PLANTATION COMMERCIAL PARK SUBDIVISION, UNIT TWO, RESUBDIVISION OF LOTS 10 AND 12

APPLICATION NUMBER 2 DATE August 15, 2019
APPLICANT Plantation Commercial Park Subdivision, Unit Two, Resubdivision of Lots 10 & 12
REQUEST Subdivision

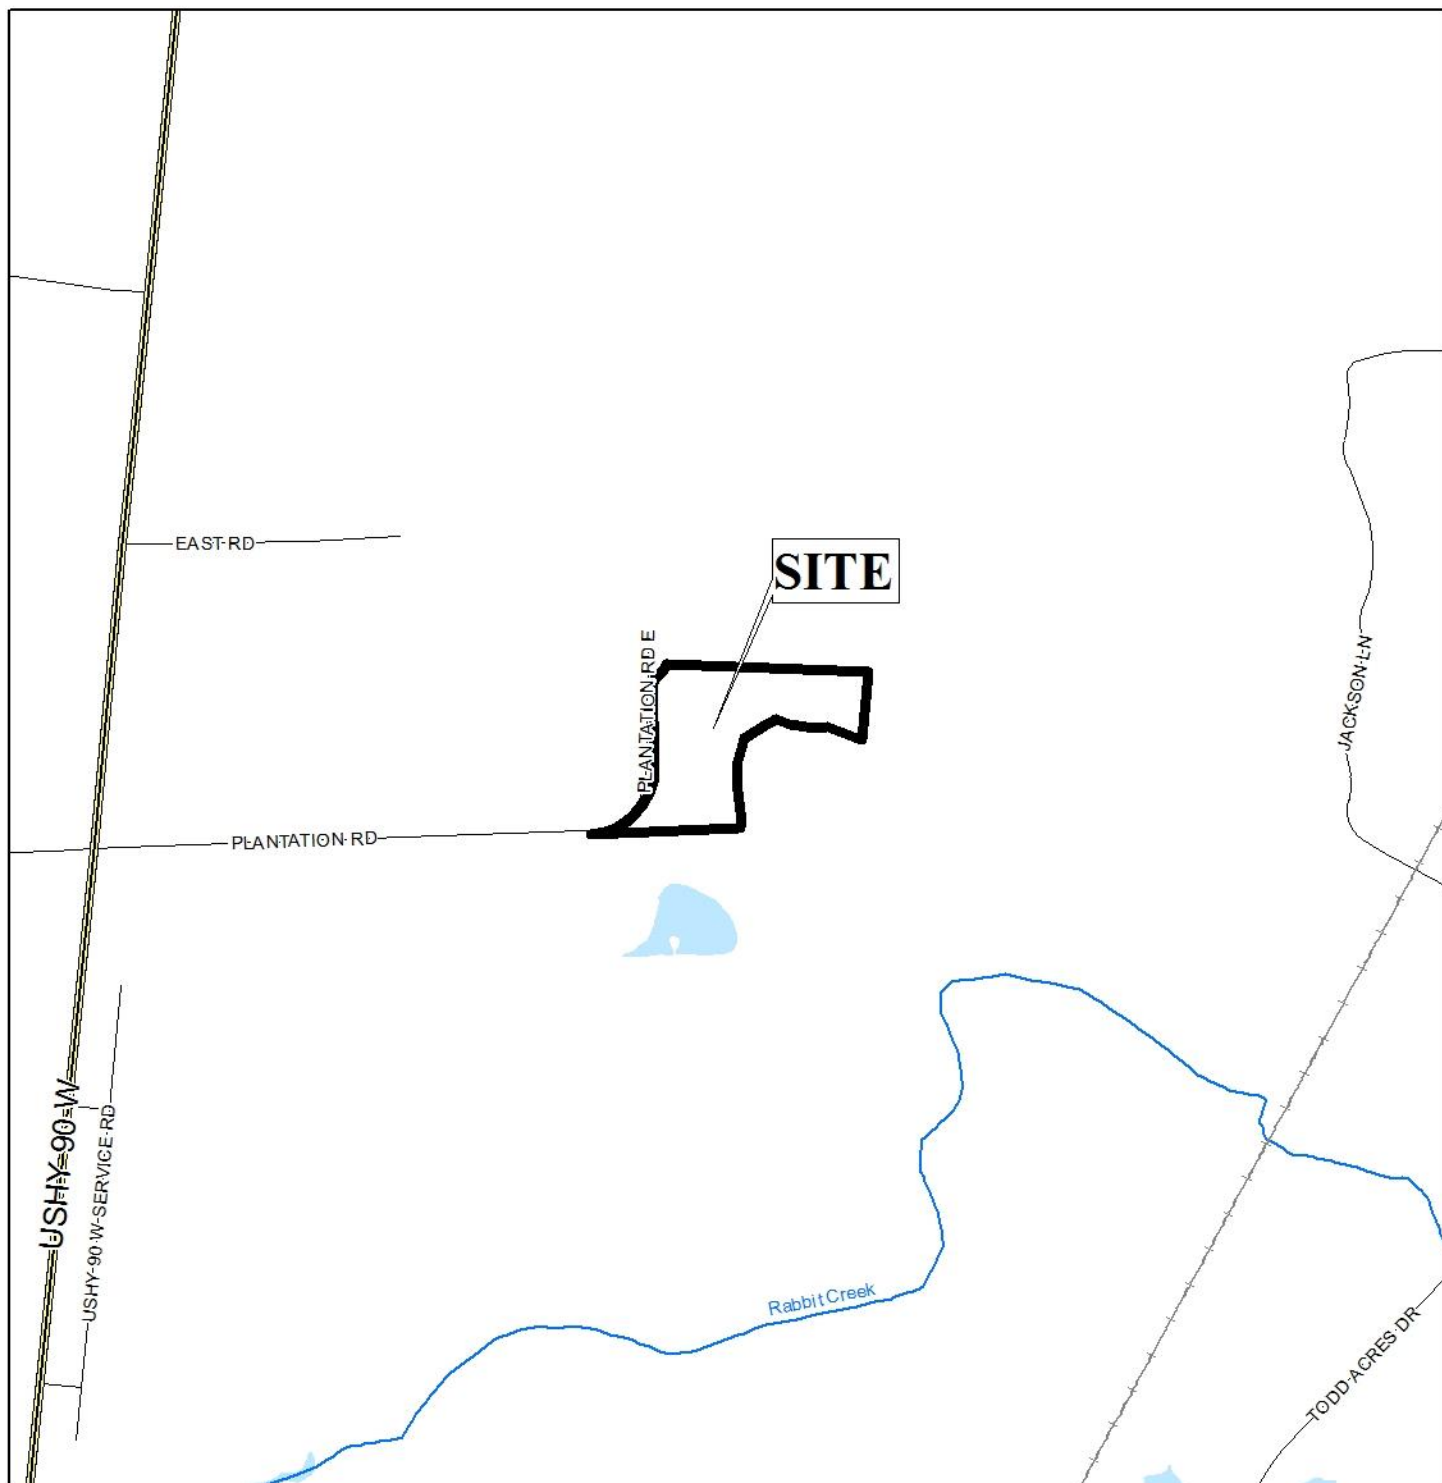
The proposed subdivision fronts Plantation Road East a minor street with curb and gutter. As a minor street, a 50’ right-of-way width is typically required. The right-of-way width of Plantation Road East, as indicated on the preliminary plat, reflects compliance with minor street standards and if approved, should be retained on the Final Plat.

As a means of access management, a note containing the Traffic Engineering Comments should be placed on the Final Plat, if approved.

As on the preliminary plat, the lot size label should be retained in both square feet and acres on the Final Plat, or a table should be furnished on the Final Plat providing the same information. The 25’ minimum building setback along Plantation Road East is illustrated and should be retained on the Final Plat. There is a 15’ drainage easement illustrated on the site that should be

indicated and labeled on the Final Plat, with a note stating that no structure may be placed or constructed within any easement.

Based upon the preceding, this application is recommended for Tentative Approval, subject to the following conditions:

- 1) retention of minimum building setback along Plantation Road East;
- 2) retention of the lot size in both square feet and acres, or the furnishing of a table on the Final Plat providing the same information;

- 3) placement of a note on the Final Plat stating that no structure may be constructed or placed within any easement;
- 4) compliance with Engineering comments: *(FINAL PLAT COMMENTS (should be addressed prior to submitting the FINAL PLAT for acceptance and signature by the City Engineer): A. Provide all of the required information on the SUBDIVISION PLAT (i.e. signature blocks, signatures, certification statements, written legal description, required notes, legend, scale, bearings and distances) that is required by the current Alabama State Board of Licensure for Professional Engineers and Land Surveyors. B. Label the monument set or found at each subdivision corner. C. Provide a note that a 25' riparian buffer may be required, during development, along the edge of anything considered by ADEM to be a water of the state. D. Provide the Surveyor's, Owner's (notarized), Planning Commission, and Traffic Engineering signatures. E. Provide a copy of the FINAL SUBDIVISION PLAT to the Engineering Dept. for review. No signatures are required on this drawing. F. After addressing all of the FINAL SUBDIVISION PLAT review comments by the Engineering Dept. provide the red-line markup, the ORIGINAL (with all other signatures) and one (1) copy of the revised original (signatures not required) of the revised Final Plat to the Engineering Department.);*
